## NEW PRODUCT ANNOUNCEMENT

NPA2003-9, June 2003

### GM 4T60E & 4T65E Molded Pan Gasket With 6mm Bolt Holes

Gasket w/6mm Bolt Holes  
TransTec #33212

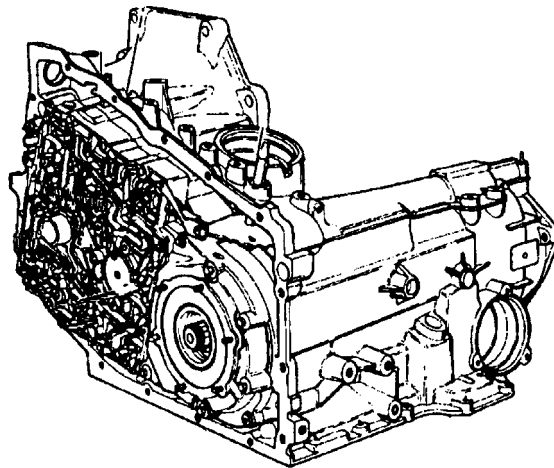
In midyear of 1998 General Motors changed the pan bolts used in the 4T60E and 4T65E from an 8mm shank to a 6mm shank. Along with this change, the size of the bolt holes in the molded pan gasket was reduced in diameter.

The 8mm bolt design gasket has been proven to perform competently in place of the 6mm design, and all TransTec kits that currently include a molded pan gasket will continue to contain only the 8mm design gasket.

However, for the discriminating builder who will not deviate from the 6mm design, TransTec is pleased to offer the 6mm design gasket in bulk under part #33212.
